**Project Name: Engineering Support Services and Recommendations for Roadside Safety Issues/Problems for Member States**

**Task 21-13: Illinois Transition Block Out Comparison with Alaska MASH TL-3 Transition Design**

**DATE: April 08, 2022**

**Figure 1. Overview of Alaska Transition and Tubing Blockouts**

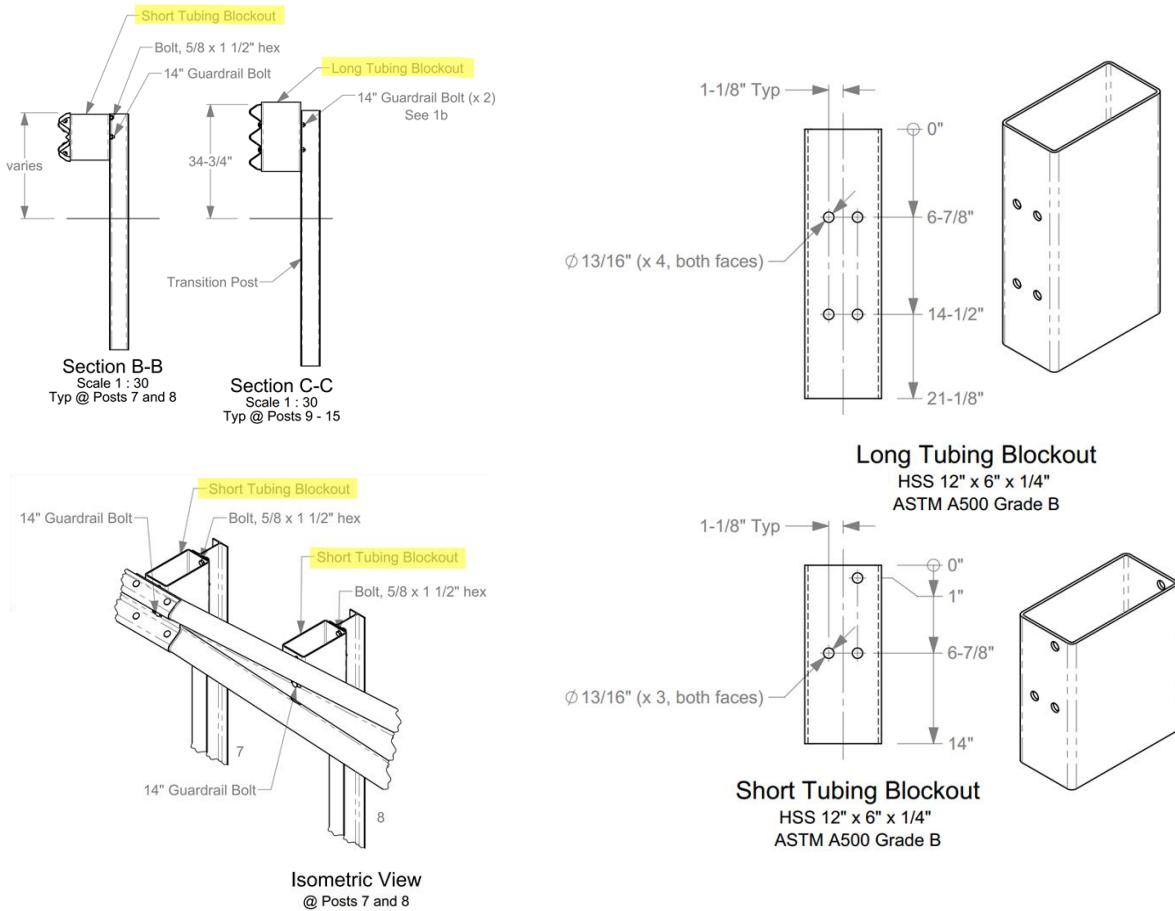
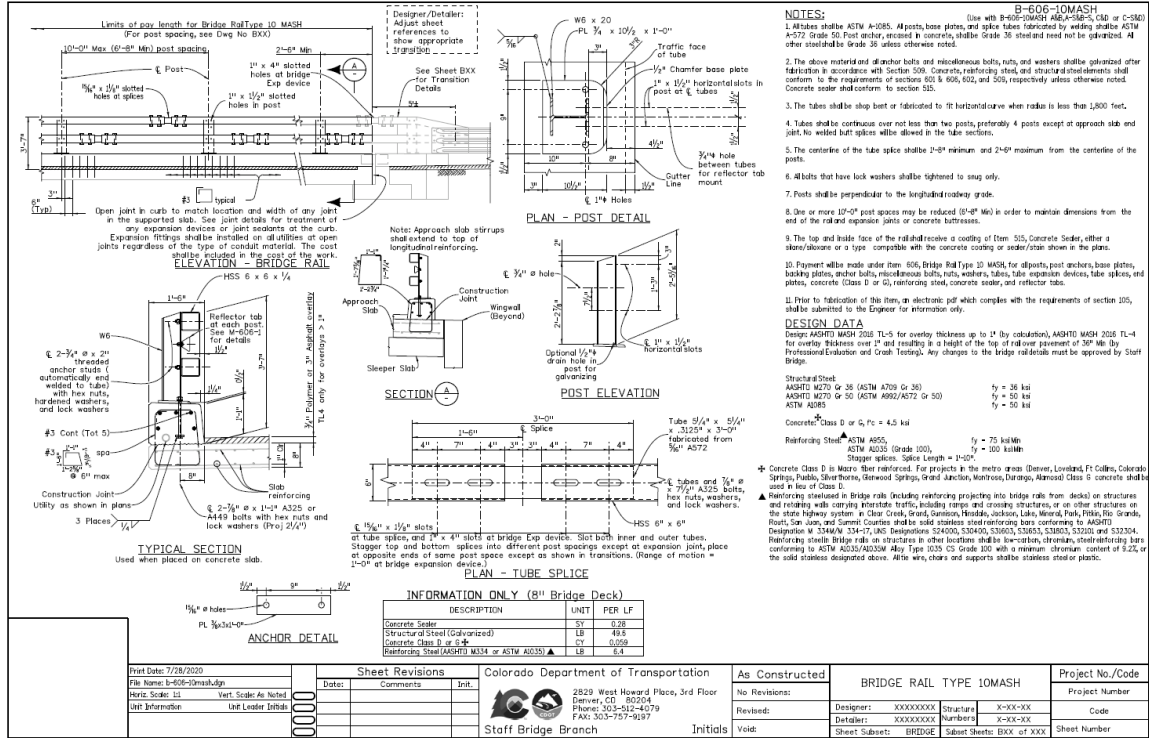
An overview of the Alaska transition and the details of the HSS tubing blockouts are presented in Figure 1. Figure 2a shows the details of the current Illinois 2-tube bridge rail bridge rail. These details are taken from the Colorado Type 10 Bridge Rail which was successfully crash tested here at TTI to MASH TL-4 in May 2020 (TTI Project 609761). Figure 2b shows the details of the Alaska 2-Tube Bridge Rail which was successfully crash tested here at TTI to MASH TL-4 (TTI Project No. 608331-1-3).

It is our professional opinion that the transition will work equally well with the wood blockouts of the same size and shape in lieu of the tested steel tubular blockouts. There has been extensive MASH testing using 12-inch wood blockouts in w-beam and thrie beam transitions. We are not aware of any issues or unexpected failure of wood blockouts causing undesirable performance with respect to the MASH Specifications in these applications. A technical memorandum was
